CITY OF ALBUQUERQUE

June 16, 2022

**Re: Stripes Burrito CO.
2781 57TH St. NW
Traffic Circulation Layout
Architect's Stamp 5-31-22 (H11-D073)**

Sheet: Traffic Circulation Layout

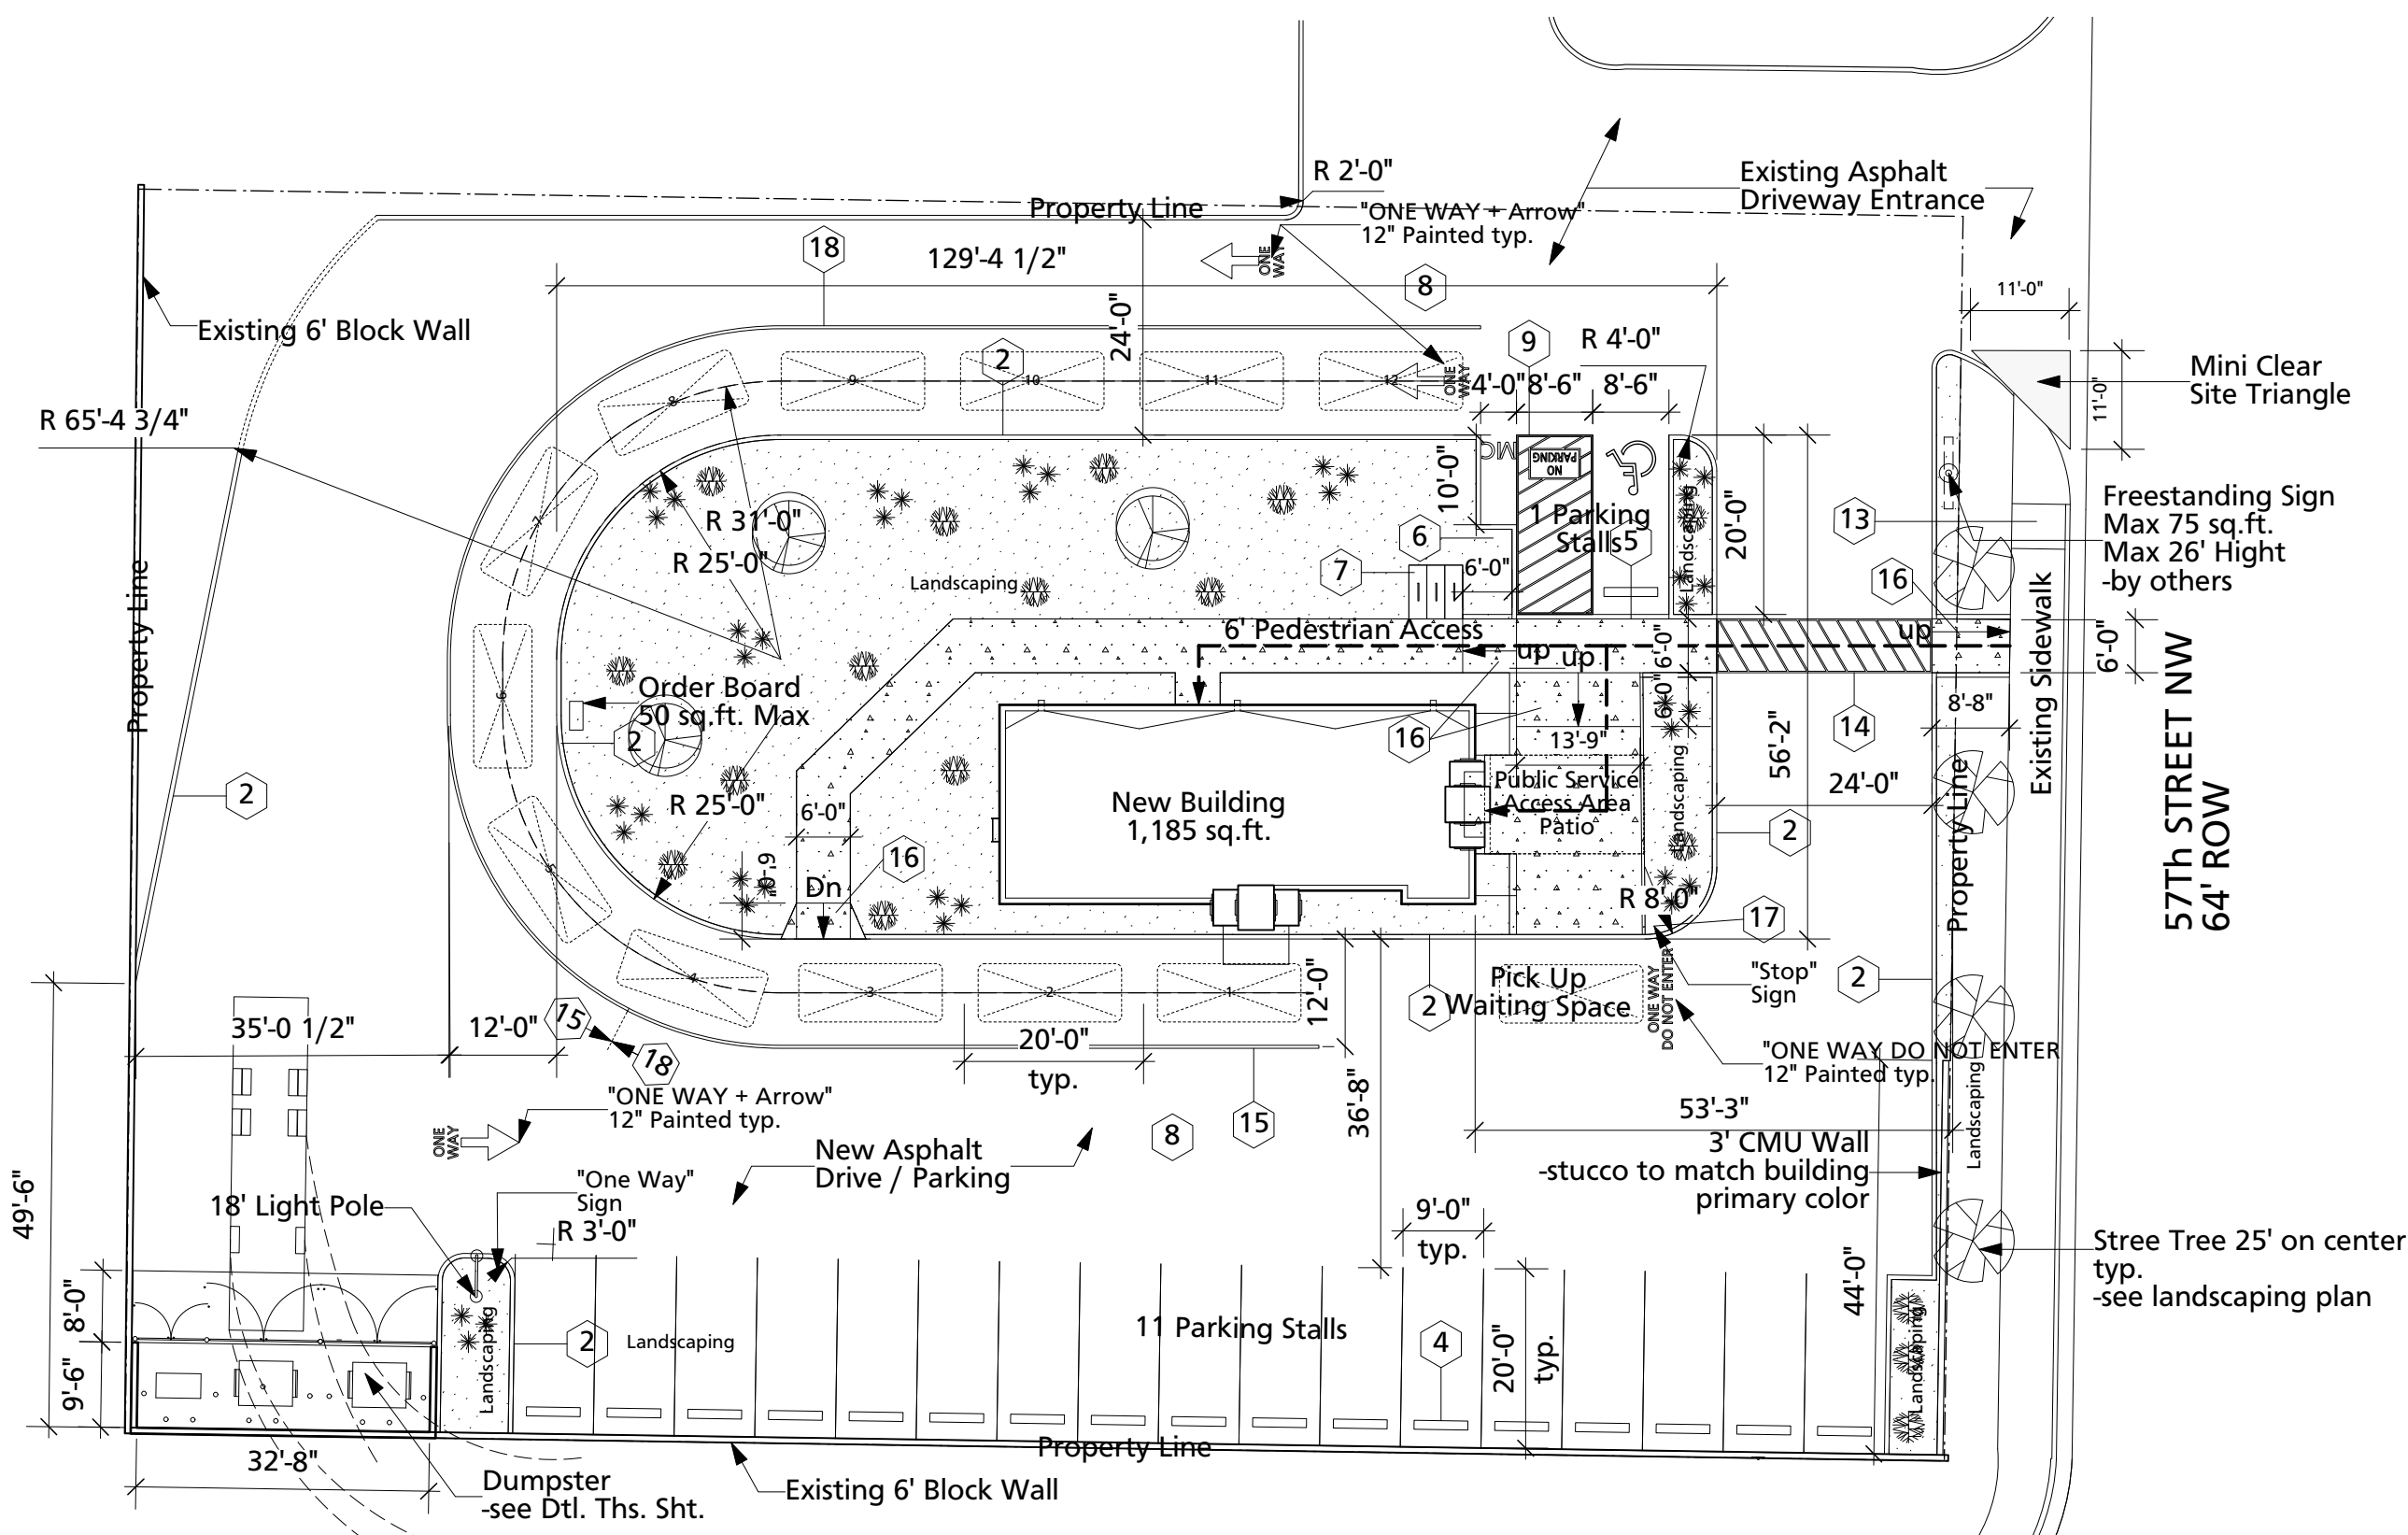
The TCL submittal received 06-07-2022 is approved for Building Permit. A copy of the stamped and signed plan will be needed for each of the building permit plans. Please keep the original to be used for certification of the site for final C.O. for Transportation.

When the site construction is completed and an inspection for Certificate of Occupancy (C.O.) is requested, use the original City stamped approved TCL for certification. Redline any minor changes and adjustments that were made in the field. A NM registered architect or engineer must stamp, sign, and date the certification TCL along with indicating that the development was built in "substantial compliance" with the TCL. Submit this certification, the TCL, and a completed Drainage and Transportation Information Sheet to front counter personnel for log in and evaluation by Transportation.
